Access Compliance Report

Public Rights-of-Way

(Curb Ramps)

Intersection ID: 10039540	Main Street: THERMAL_RD	Cross Street: N/A	Location: SW
ADA ID: CAC0AEC01268	Ramp Type: Directional1	Initial Pass/Fail: Fail	Overall Compliance: No
			Severity Score: 33.75

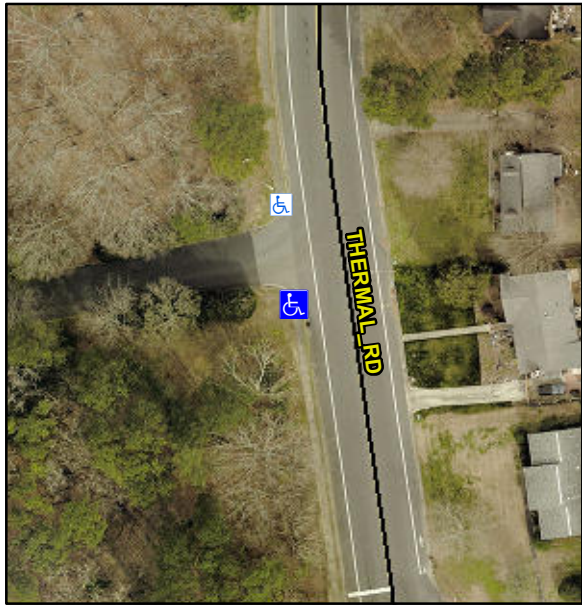
Surveyor Notes:																				
		ASP LIP 1.0", CURB LIP 0.5"																				
		PROW/ADA:																				
		R304.5.1, R304.5.3																				
		Total Cost:		\$	1600.00

Codes/Mitigation Info/Possible Solution			Field Measurements/Component Compliance																			
	Possible Solutions:		Compliance			Description			Data		Compliance			Description			Data					
	Remove & Replace Entire Ramp.		N/A	Ramp Length (in)		55.0		N/A	Grade Break?		N/A		N/A	Grade Break Slope (%)		0.0		N/A	Grade Break XSlope (%)		0.0	
			No	Ramp Width (in)		47.5		N/A	Grade Break Slope (%)		0.0		N/A	Grade Break XSlope (%)		0.0						
			Yes	Ramp Slope (%)		2.6		N/A	Grade Break XSlope (%)		0.0											
			No	Ramp XSlope (%)		8.1																
			N/A	Flare Type LT		N/A		N/A	Flare Type RT		N/A											
			N/A	Flare Slope LT (%)		N/A		N/A	Flare Slope RT (%)		0.0											
			N/A	Flare Traversable LT?		N/A		N/A	Flare Traversable RT?		N/A											
			N/A	Landing Length (in)		0.0		N/A	DWS Provided?		N/A											
			N/A	Landing Width (in)		0.0		N/A	DWS Contrast?		N/A											
			N/A	Landing Slope (%)		0.0		N/A	DWS Length (in)		N/A
